RE: Munn Avenue Pedestrian Trail
STP-4300(108)
Addendum No. 1

Addendum No. 1

**Munn Avenue Pedestrian Trail
STP-4300(108)
Maryville, Missouri**

PORTLAND CEMENT CONCRETE SIDEWALK / CURB TYPICAL SECTION

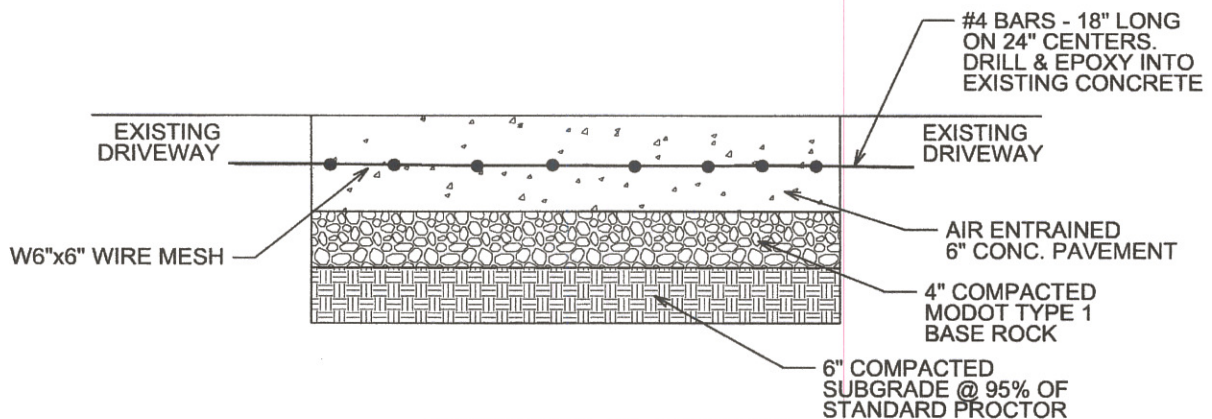
1. See attached exhibit showing revised cross sections with 4" base rock.

1. Base Rock – 4" of compacted MoDOT type 1 base rock shall be placed under all sidewalks and driveways constructed. 6" of base rock shall be placed under the future street crossings as shown on the plans. The price of the base rock shall be included in the unit price of the concrete pavement.
2. Tree Removal – Trees that are to remain have been marked with white paint. Contractor shall remove all other trees and roots completely. If utility conflicts disrupt root removal, notify the City and engineer.
3. Tree Planting Schedule – If all other work is complete, a time extension will be considered if needed to meet the recommended planting dates for the new trees.
